Memorandum

Dakota Springs Engineering

Subject: Waterview Final Plat
SF-16-017

This memorandum has been prepared to address the comments you provided concerning the Springs at Waterview Final Plat in your letter dated November 28, 2017. Your comments are provided below with our response comment immediately following in *italics*.

PROJECT TITLE: **MASTER UTILITY PLAN**
 SHEET NO. **0001-02-18-01** TO **02**
 SHEET **18** OF **22**

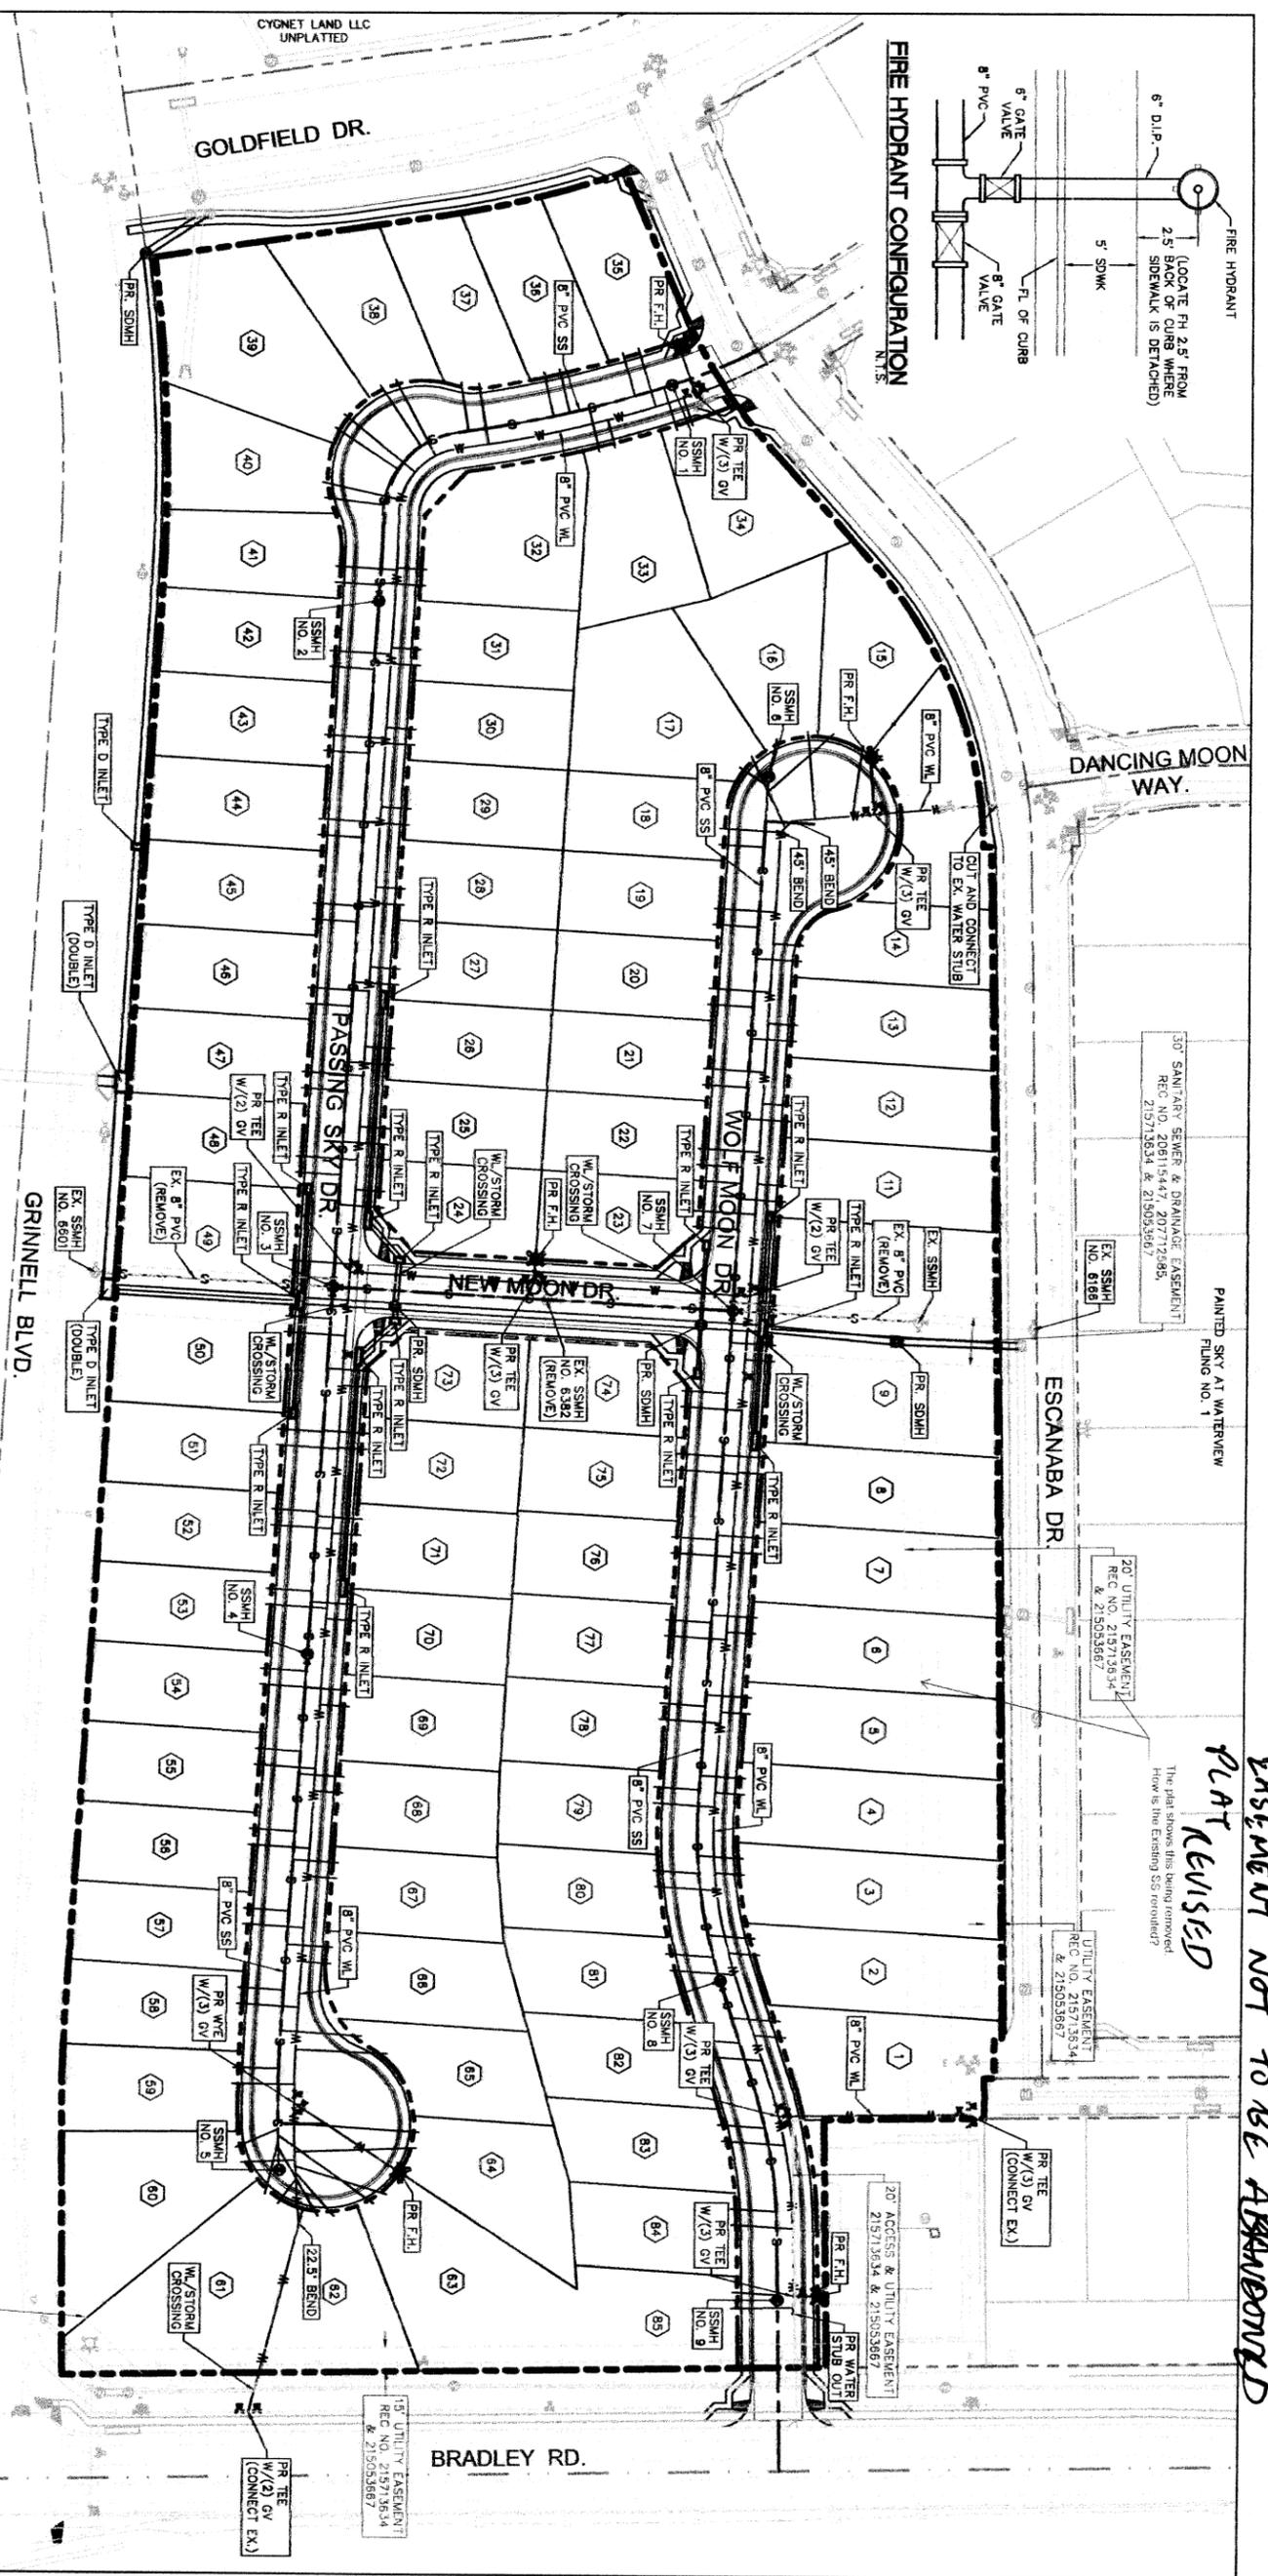
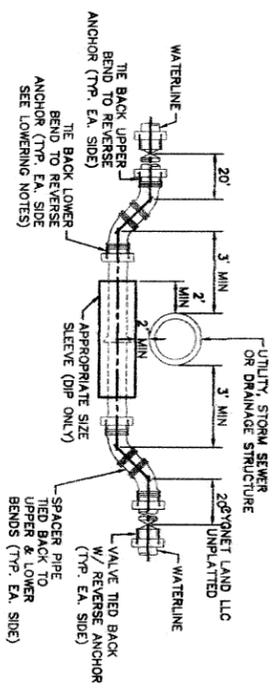
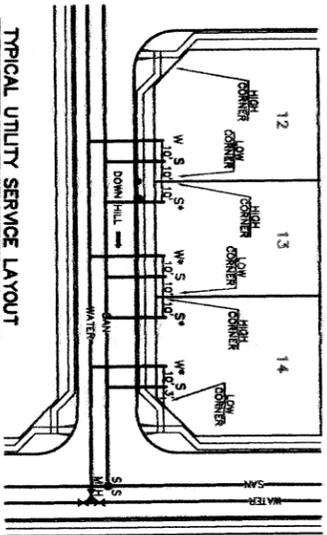
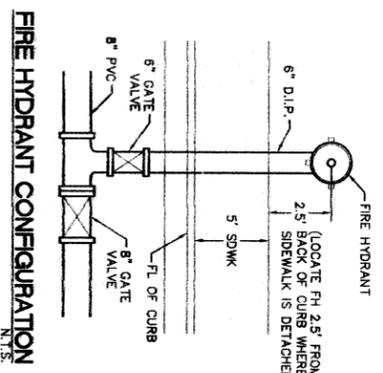
EASEMENT NOT TO BE ABANDONED
PLAT REVISED
 The plat shows this being removed
 How is the Existing SS rerouted?
